# Access Compliance Report

## Public Rights-of-Way

### (Curb Ramps)

Intersection ID: 20620	Main Street: OLD_REID_RD	Cross Street: WADEBRIDGE_CV	Location: E
ADA ID: 077ABDDC2F78	Ramp Type: PerpDiag	Initial Pass/Fail: Fail	Overall Compliance: No
Severity Score: 12.5			
Codes/Mitigation Info/Possible Solution		Field Measurements/Component Compliance

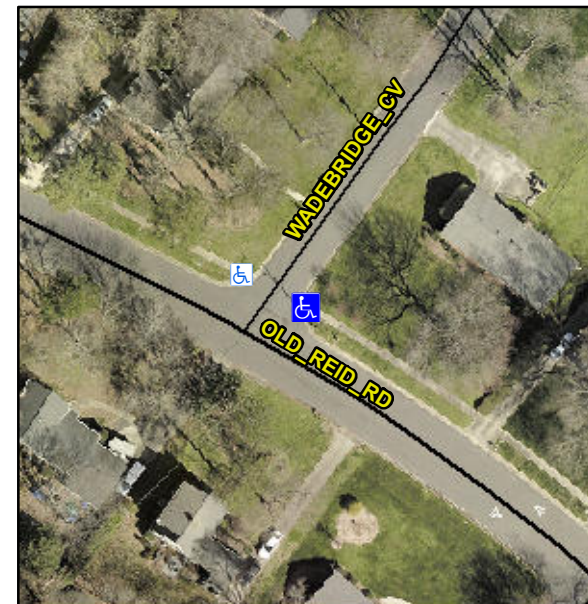
**Not Found, R304.2.2**

Compliance	Description	Data	Compliance	Description	Data
N/A	Ramp Length (in)	48.0	No	Ramp Slope (%)	9.2
Yes	Ramp Width (in)	48.0	Yes	Ramp XSlope (%)	1.7
N/A	Flare Type LT	N/A	N/A	Flare Type RT	N/A
N/A	Flare Slope LT (%)	N/A	N/A	Flare Slope RT (%)	N/A
N/A	Flare Traversable LT?	N/A	N/A	Flare Traversable RT?	N/A
N/A	Landing Length (in)	N/A	N/A	DWS Provided?	N/A
N/A	Landing Width (in)	N/A	N/A	DWS Contrast?	N/A
N/A	Landing Slope (%)	N/A	N/A	DWS Length (in)	N/A
N/A	Landing X Slope (%)	N/A	N/A	DWS Full Width?	N/A
N/A	Landing Curb? (Y/N)	N/A	N/A	DWS Offset (in)	N/A
N/A	Shared Landing?	N/A			
N/A	Gutter Ponding?	N/A	N/A	Gutter Slope (%)	N/A
N/A	Gutter Lip Ht (in)	N/A	N/A	Gutter X Slope (%)	N/A
N/A	Painted X Walk1?	No	N/A	Painted X Walk2?	No
	X Walk 1 Direction	To NW		X Walk 2 Direction	To SW
N/A	X Walk 1 Width (in)	N/A	N/A	X Walk 2 Width (in)	N/A
	X Walk 1 Slope (%)	0.4		X Walk 2 Slope (%)	1.2
	X Walk 1 X Slope (%)	2.5		X Walk 2 X Slope (%)	1.1

**Remove & Replace Curb Ramp With Two New Directional Ramps or Equivalent.**
